Variance Request Form

Ocotillo Express Wind LLC
Pier 1 Bay 3
San Francisco CA 94111
415-283-4000

Variance: 030
Request No.: Rev 0
Date Submit: 10/17/2012
Date Approval Needed: 10/19/2012
Date Agency Received: _____
Agency Approval Reference No.: _____

OCOTILLO WIND PROJECT: IMPERIAL COUNTY, CALIFORNIA

VARIANCE 30 - OCTOBER 17, 2012

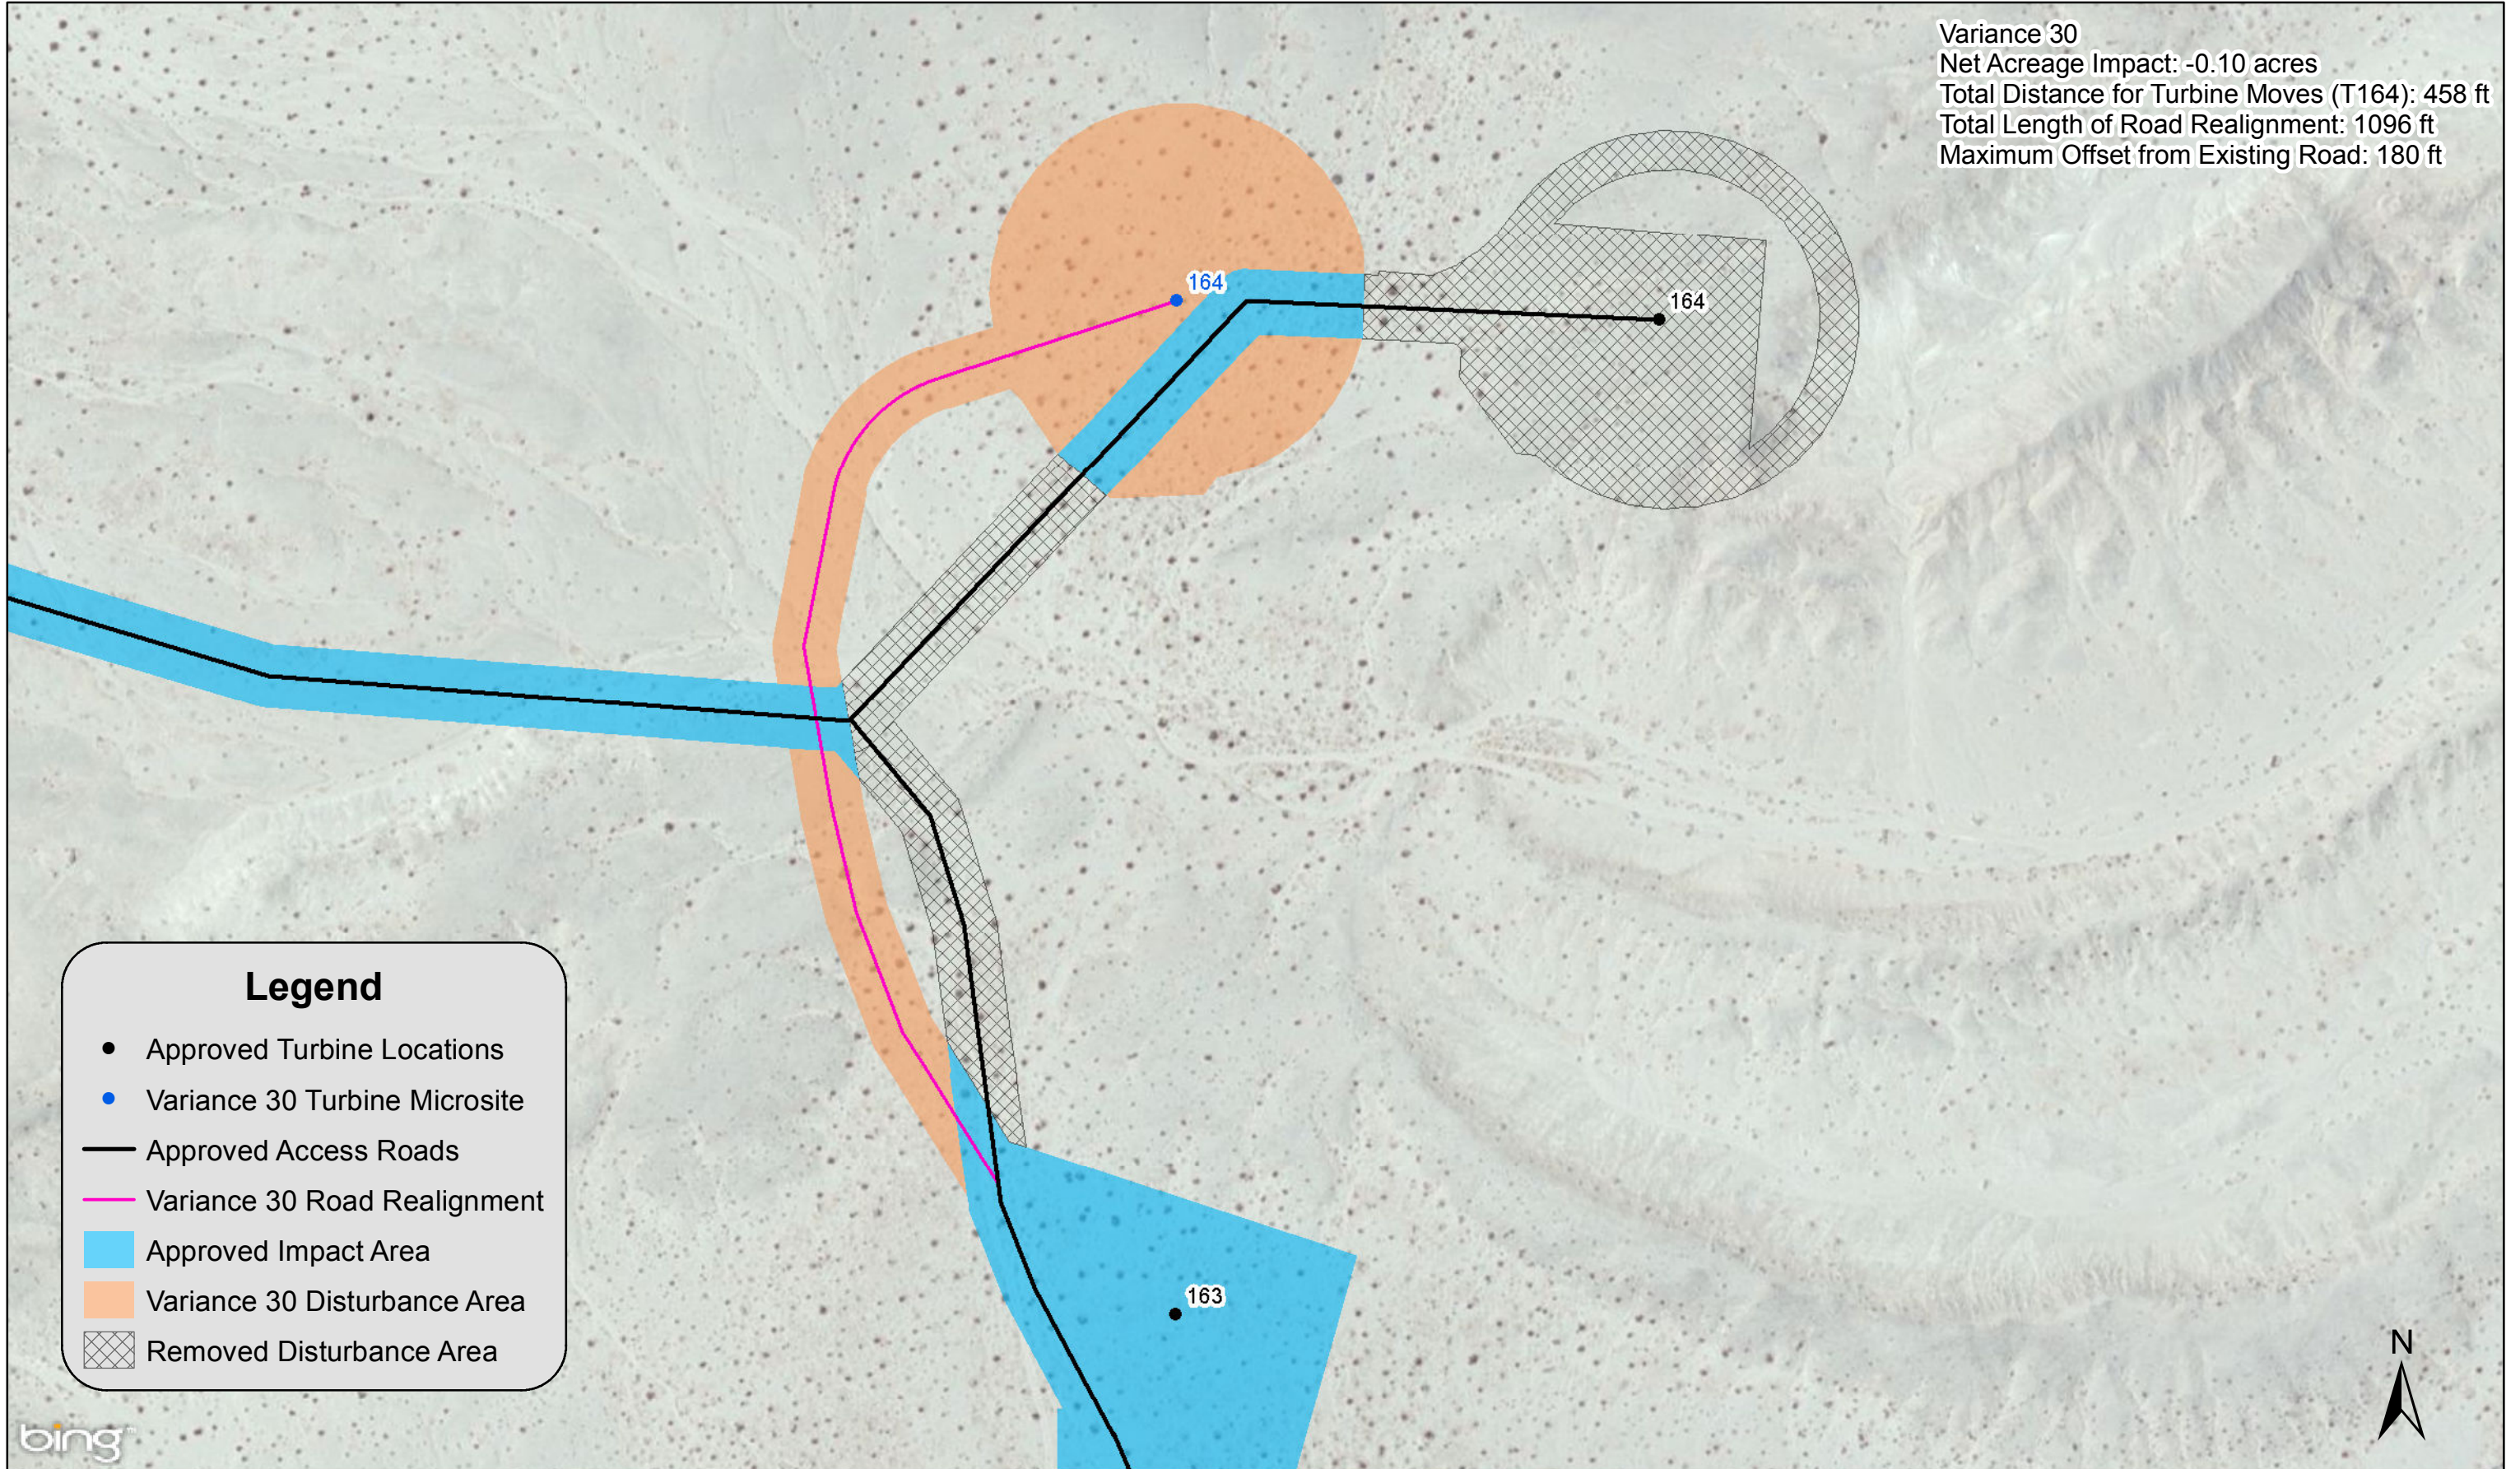
Variance 030 includes a location shift of Turbine 164 as well as realignment of the access road leading towards Turbine 164 (see map attachment). The proposed shift of Turbine 164 is 458 feet from its currently approved location. The total length of the road realignment towards Turbine 164 is 1096 feet with a maximum offset of 180 feet from the currently approved access and collection circuit corridor alignment.

Variance 30
Net Acreage Impact: -0.10 acres
Total Distance for Turbine Moves (T164): 458 ft
Total Length of Road Realignment: 1096 ft
Maximum Offset from Existing Road: 180 ft
